UNITED STATES PATENT AND TRADEMARK OFFICE

Office Action Summary

10/670,244

DETAILED ACTION

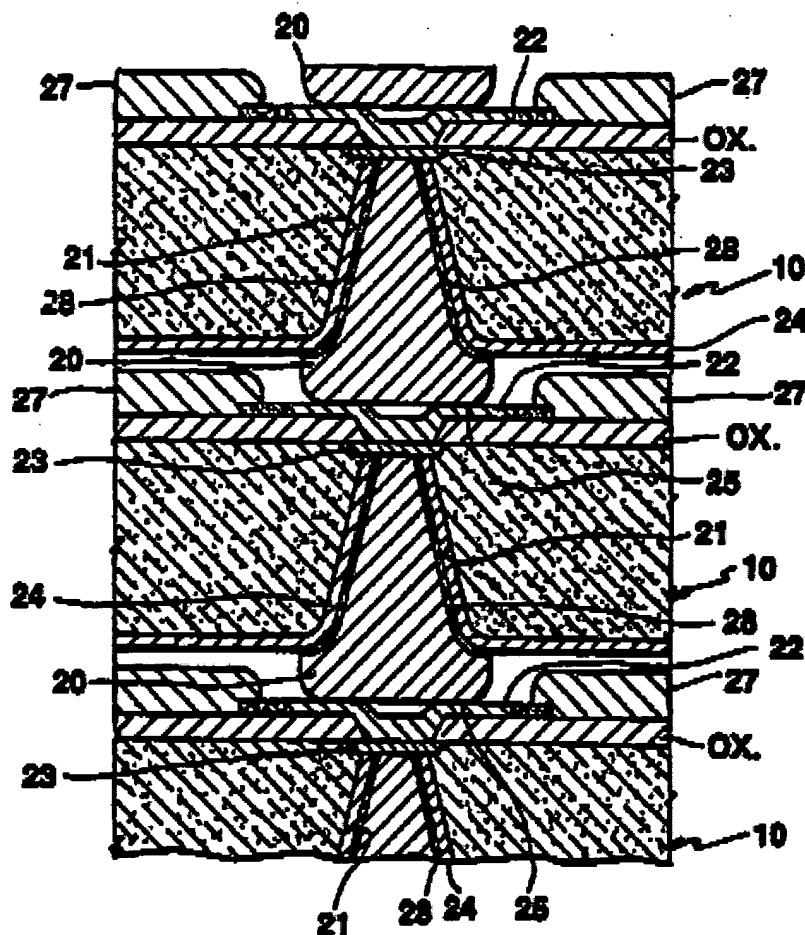
5. Claims 1, 2, 13, 14, 17 and 18 are rejected under 35 U.S.C. 102(b) as being anticipated by Gnadinger (US 005229647A).

6. Regarding claims 1, 13, 14 Gnadinger (e.g. fig. 4) shows chip staked semiconductor device comprising multiple stacked semiconductor chips, each semiconductor chip includes multiple through electrodes 20 in a semiconductor chip 10 linking a front surface to a back surface thereof, wherein the through electrodes have mutually differing cross-sectional areas. The through electrodes are electrically connected to the semiconductor chips via pads 25 (col. 2/lis. 6-21 & 49-62). Because the electrodes are conical or parabolical, they have "n" number of cross sectional areas that increase in upward direction (y direction). For example, an upper cross section area of one electrode is smaller than a lower cross sectional area of the same electrode or another electrode.

7. Regarding claim 2, Gnadinger shows that at least one type of the through electrodes is contact through electrodes electrically connected to the semiconductor chip via pads 25 (col. 2/lis. 6-21 & 49-62).

8. Regarding claims 17 and 18, Gnadinger teaches that the cross-sectional areas of those through electrodes which connect $n+1$ or more adjacent semiconductor chips are greater than the cross-sectional areas of those through electrodes which connect n adjacent semiconductor chips, where n is an integer more than or equal to 2. Note that each of the electrodes 20 connects multiple adjacent chips 11 (i.e. more than 3)

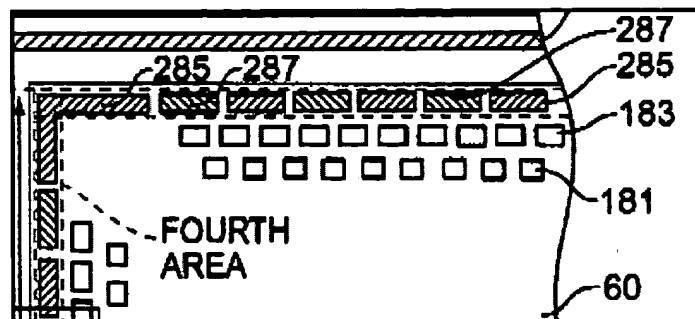
11. Regarding claims 1 and 9, Terui (e.g. fig. 5A) shows a semiconductor device, comprising multiple electrodes (181, 183, 285, 287) formed on a front surface of a semiconductor chip 60 wherein the through electrodes have mutually differing cross-sectional areas. Also, the cross sectional areas of the electrodes 285/287 connected to the power supply are greater than the cross sectional areas of those electrodes 181/183 which are connected to the signal terminal. Terui does not show that the electrodes are "through electrodes" linking the front surface and back surfaces of the chips.

Nevertheless, Gnadinger (e.g. fig. 4) shows through electrodes 20 linking front and back surfaces of the semiconductor chip 10/11. According to Gnadinger a very low cost high-density package can be obtained by using this type of through electrodes because this type of electrodes form reliable and inexpensive connections (col. 1/lls. 35-39 & 49-57). It would have been obvious to one of ordinary skill in the art at the time the invention was made to use through electrodes linking the front and back surface of Terui's chip to stack several chips in order to make a very low cost high density package as taught by Gnadinger because this type of through electrode forms reliable and inexpensive connections.
